GOVERNMENT OF THE DISTRICT OF COLUMBIA
DEPARTMENT OF TRANSPORTATION

MEMORANDUM

SUBJECT: ZC Case No. 16-03 – Hill East

Figure 2 Loading Facilities and Circulation (Source: Wells + Associates)

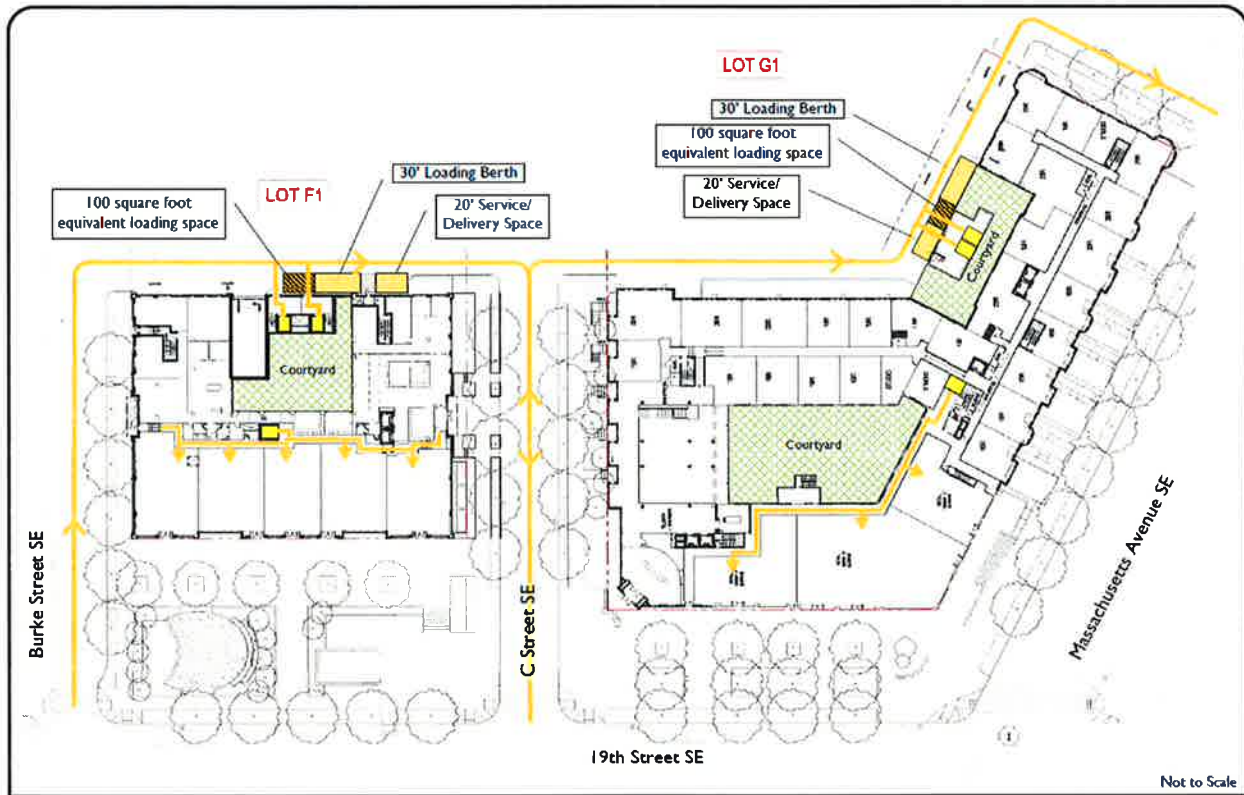
Loading for both buildings is proposed via the private alley. Loading areas are proposed on the surface of the private alley as shown in Figure 2 rather than within the footprint of each building. The Applicant proposes a series of freight elevators and service corridors to connect the loading facilities with each retail bay and residential unit.

Of note, the proposed loading facilities for each building – a 30-foot loading berth and a 20-foot service delivery space – can be combined to create a 50-foot loading berth to accommodate a larger truck, if the need to serve a larger truck arises. However, as discussed in the Loading Management Plan, the Applicant proposes to limit access to the loading berths to trucks larger than 30 feet.

DDOT finds the loading management plan sufficient to mitigate potential loading impacts.
